## Administrative Action Preliminary Subdivision

**Case File / Name:** S-61-14 / Breedlove Subdivision (Revised)

**Nature of Case:** Subdivision of one lot into 2 lots, currently zoned Residential-10 District. Proposed lot # 2 fronts Ridley Street, lot #1 is a corner lot. This was submitted post September 1, 2013, and is subject to the Unified Development Ordinance. This is a modification of the original plan approved on April 7, 2015 (AA# 3256). The modifications include use of a design adjustment for street tree requirements and payment of a fee in lieu of sidewalk construction. The sunset date for the project is unchanged. This includes a new condition of approval, number 5.

Preliminary Subdivision Plan – Breedlove Subdivision Revised

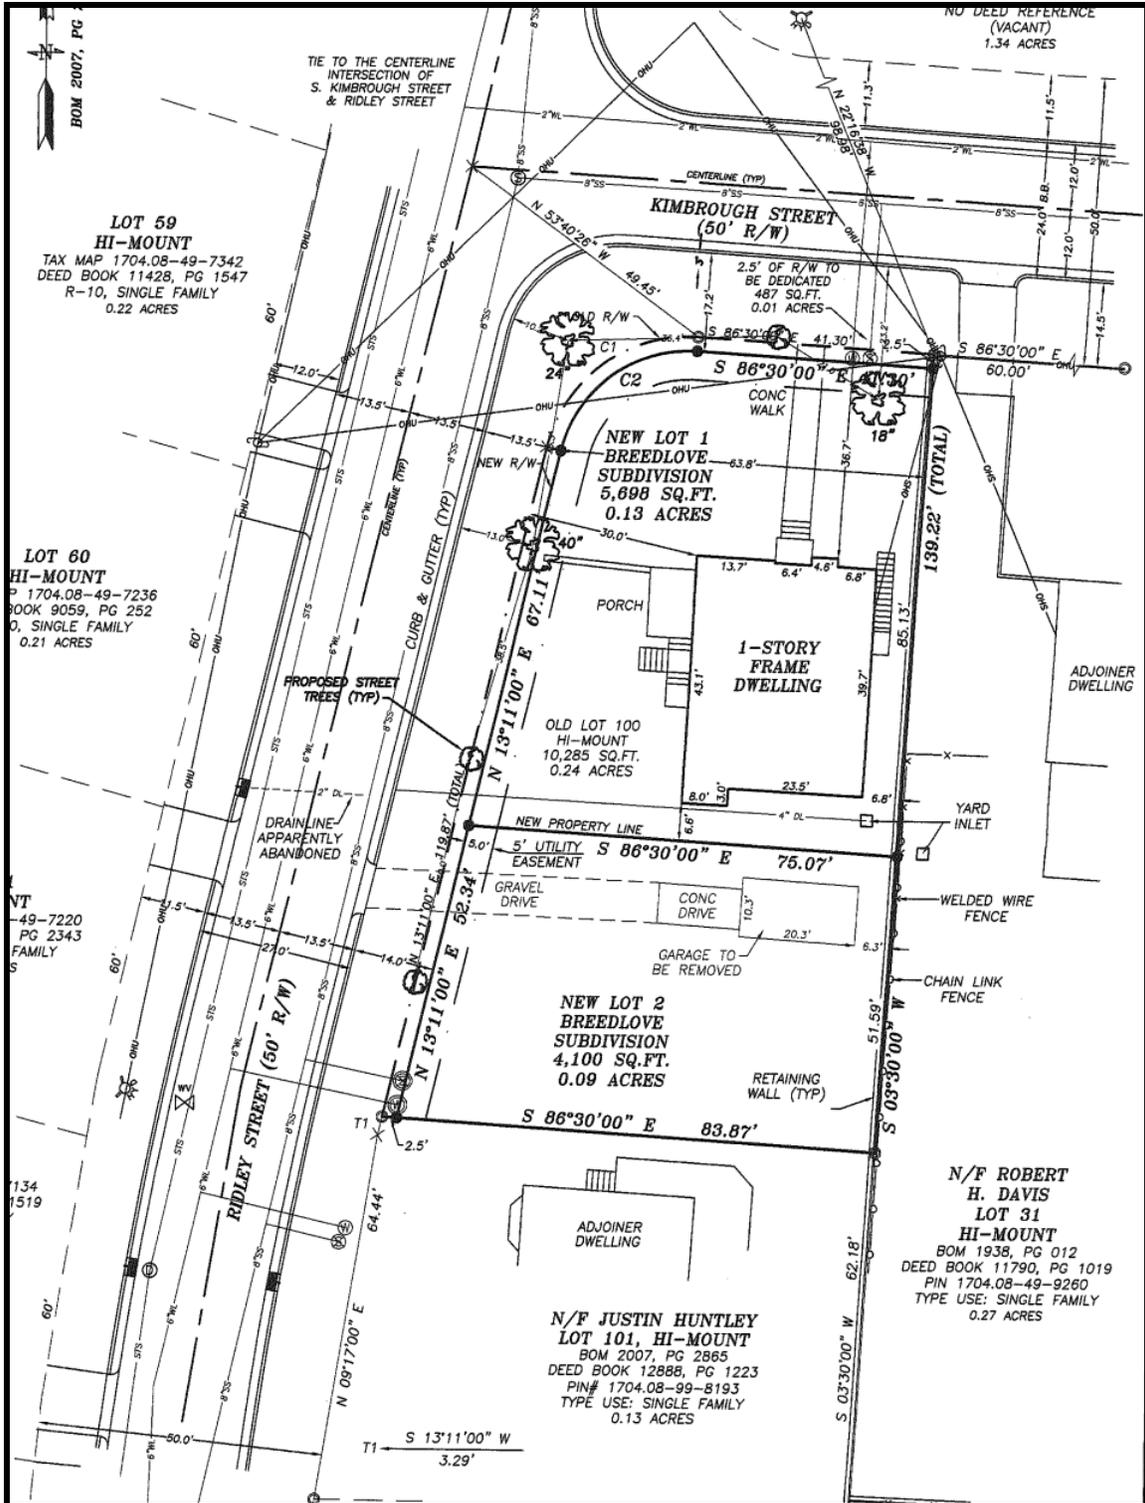
1. A Design Adjustment has been approved for the allowance of the streetscape tree requirement being met utilizing two existing and established shade trees while providing additional trees spaced 40' on center for the frontage along both streets. (8.5)

Given the existence of the two large oak trees and the desire for consistency in the streetscape, staff is in **SUPPORT** of this request.

- (5) That a fee in lieu shall be paid to the City of Raleigh for 6' width of sidewalk running the length of the frontage along both Kimbrough and Ridley Street(s).
